**ZILKER NEIGHBORHOOD ASSOCIATION PRESENTATION  
TO THE PLANNING COMMISSION HEARING (27 AUG 2019)  
ON 211 SOUTH LAMAR PUD REZONING**

211 South Lamar PUD

**Date:** July 16, 2019  
**To:** Wendy Rhoades, Zoning Case Manager  
**CC:** Dan Hennessey, P.E., Big Red Dog/WGI  
 Eric Bollich, P.E., PTOE, Austin Transportation Department  
 Upal Barua, P.E., P. Eng., PTOE, Austin Transportation Department  
**Reference:** 211 S Lamar Blvd (PUD Amendment) – Transpiration Mitigation Memo  
 C814-2012-0160.01

## Data Plot and Equation

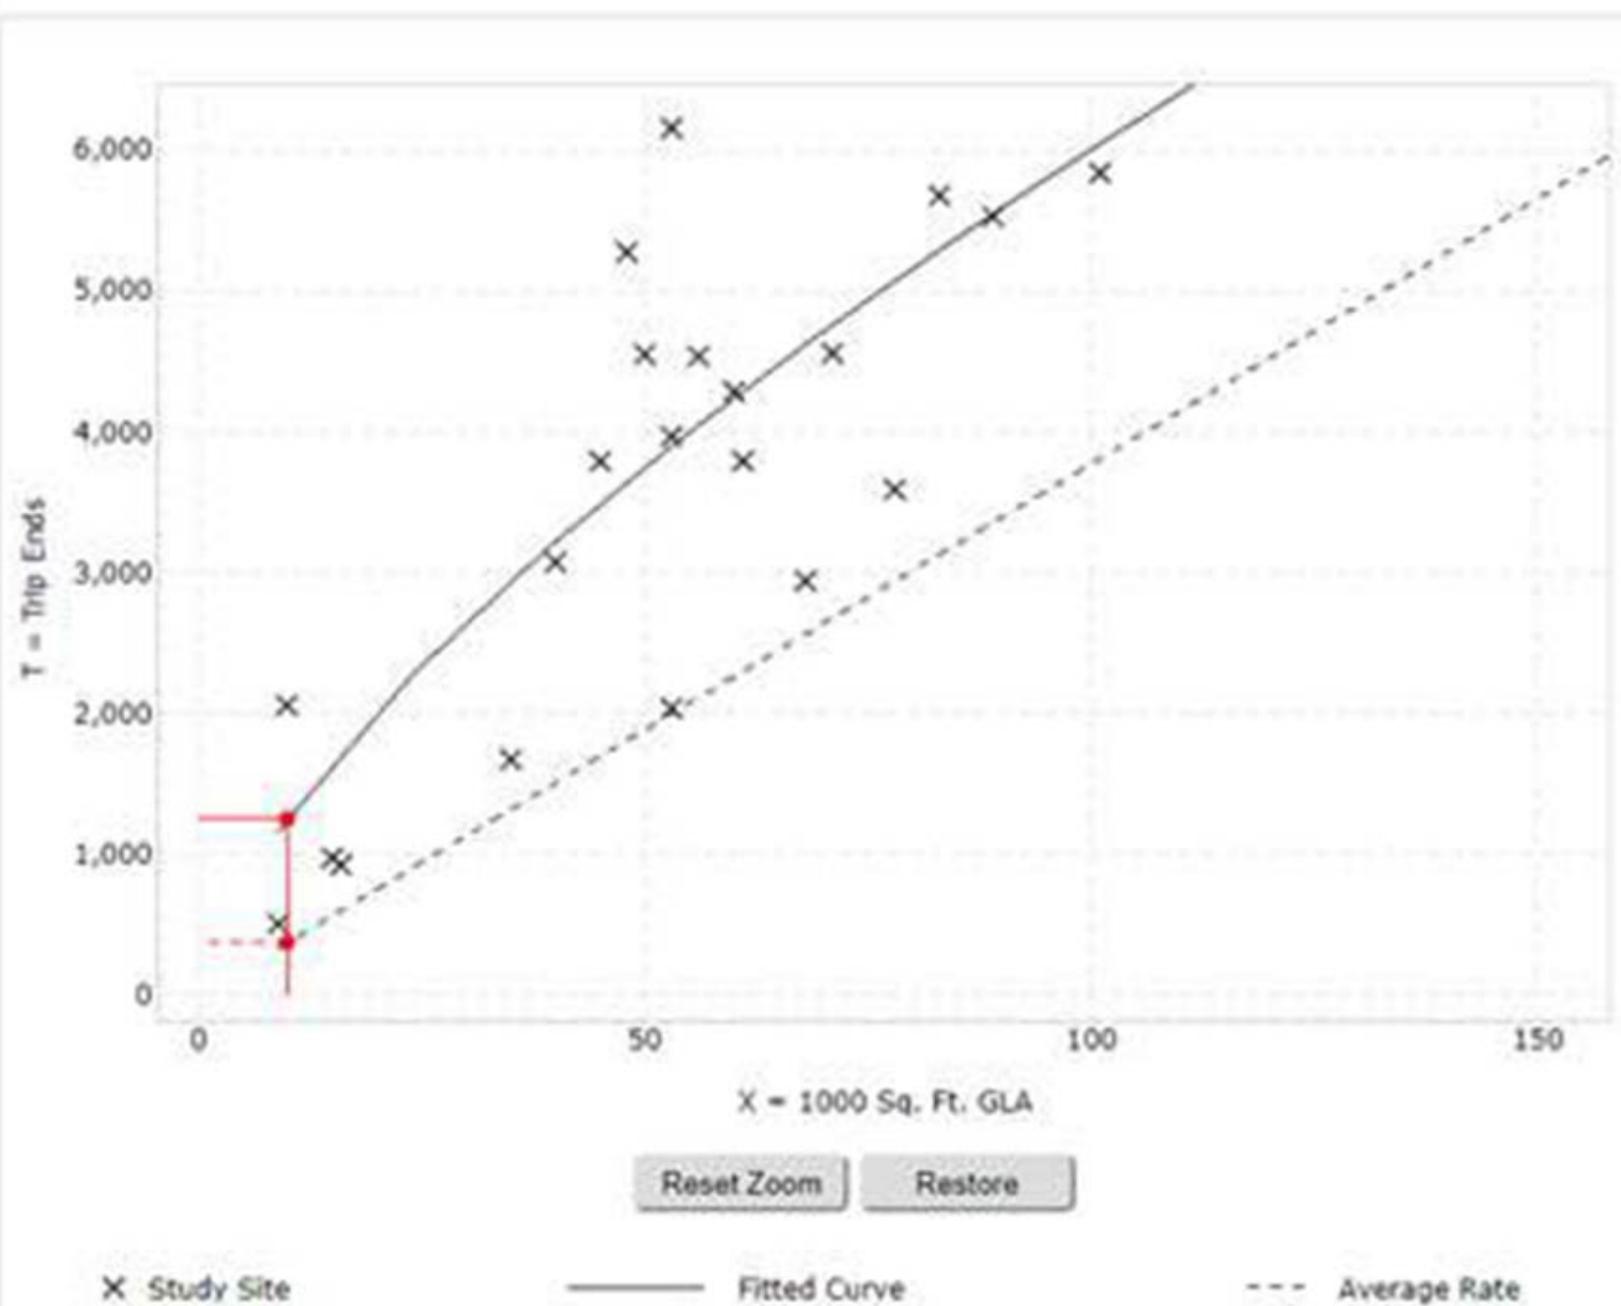
- 2) The original project consisted largely of natural building materials; the new project appears to be almost entirely glass.
- 3) The original project had a daily traffic volume of 2,006 vpd; the daily traffic volume of the new project has increased to 2,320 vpd. The daily traffic volume of the new project would be even higher if the traffic volume from the retail shopping area had not been reduced from the original projection by what we believe was the questionable decision to use an average rate rather than a fitted curve.

EXHIBIT 2

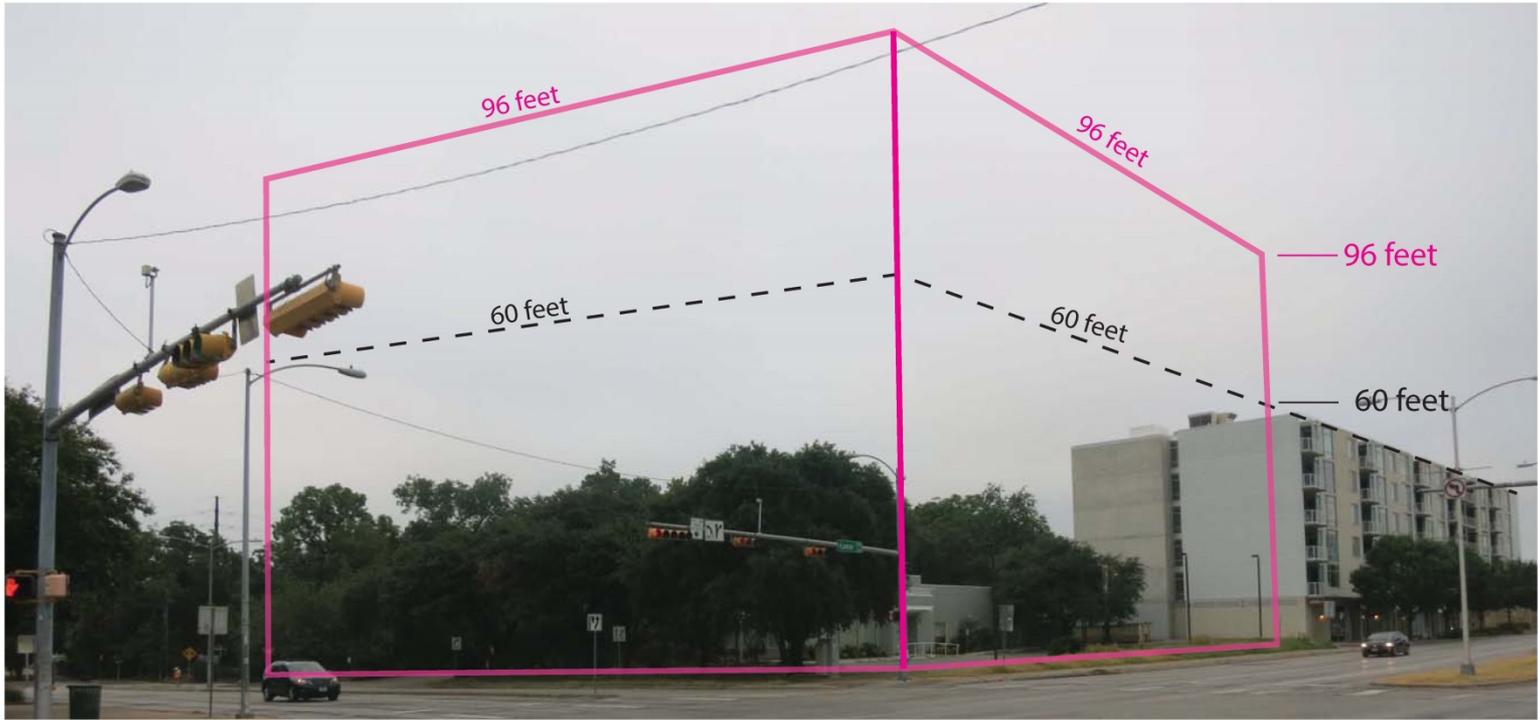
This building will dominate the view along Butler Shores and the southern view from the Pfluger Pedestrian Bridge as one crosses the lake. It will loom over Butler Pitch and Putt where the view still feels like a park setting. However, it will not feel like a park setting when a 96-foot glass building looms over the northern end of the course.

View from Pfluger Pedestrian Bridge  
(dashed red line shows 96' height at edge of The Bridges; solid red line shows approximate location of hotel)
